PUBLIC NOTICE Amendment

The permittee for P/N# OCRM-03-284-M, Paul Bryer has requested an amendment to that issued permit. Specifically, the applicant proposes to replace the permitted 12' by 12' four-pile boatlift with an 11' by 18' floating boatlift to be relocated on the upstream end of the floating dock. The applicant also proposes to increase the dimensions of that floating dock to a 10' by 23' structure and to reconfigure the permitted 20' by 20' fixed pierhead to an 18' by 18' covered structure. The proposed amendments are for changes to a private recreational use dock on Rantowles Creek at Lot 2, Tract F, Bulow Point Road, Bulow Plantation Subdivision, Charleston County, South Carolina.

REF: PERMIT # O.C.R.M 03-284-M

AMENDMENT

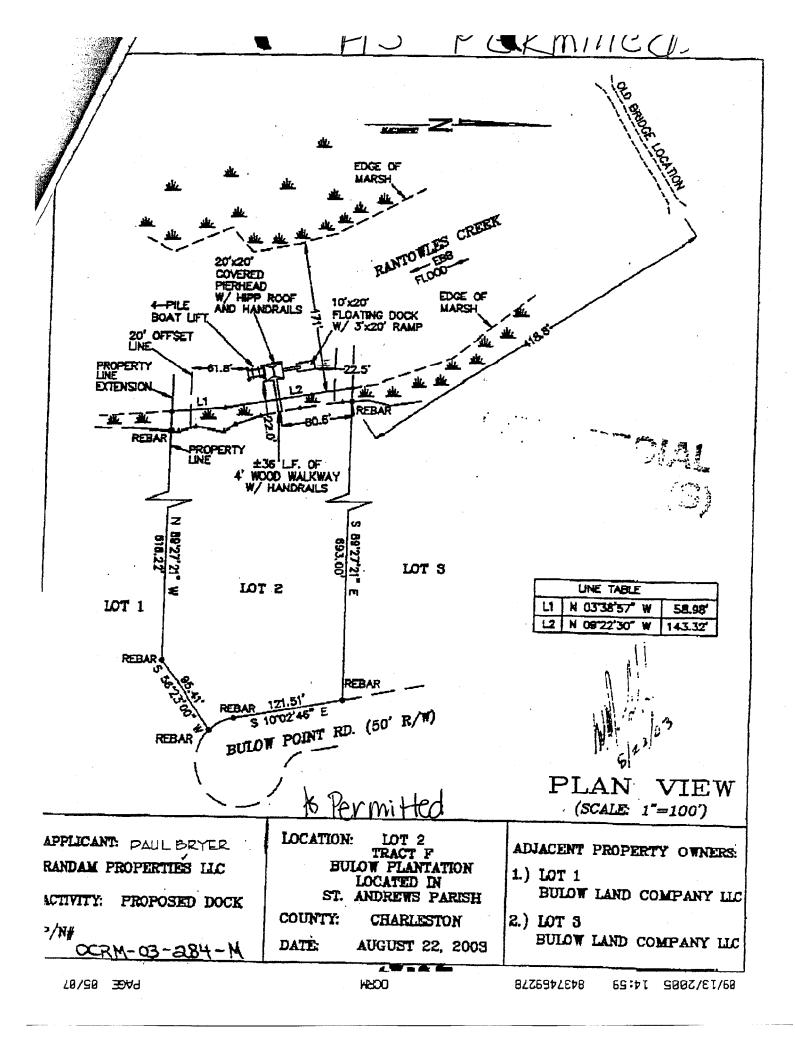
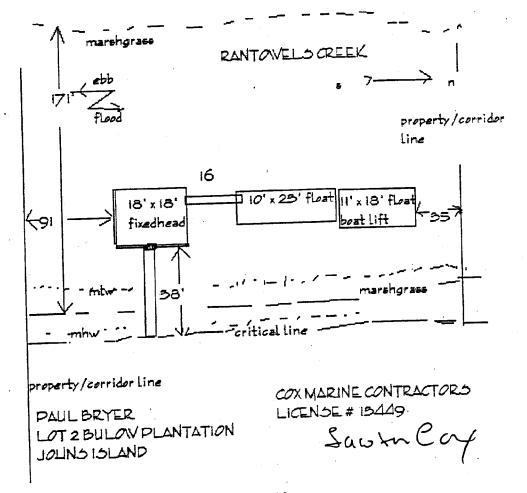
Please amend Permit # O.C.R.M 03-284-M for Paul Bryer to move his permitted four pile boat lift to the end of his permitted floating dock. and change it to a floating boat lift. He would also like to change his permitted 10' x 20' floating dock to a 10' x 23' floating dock. He would also like to reduce his permitted 20' x 20' fixed head to a 18' x 18' fixed head.

(1) 18x 18' fixed head

(2) 10' x 23' floating dock

(3) 11' x 18 floating boat lift

This is the same square footage as he is presently permitted for as we discussed. Also note that the floating boat lift will be 35' from the projected property line of lot 3 and the pierhead will be 91 feet from lot 1.
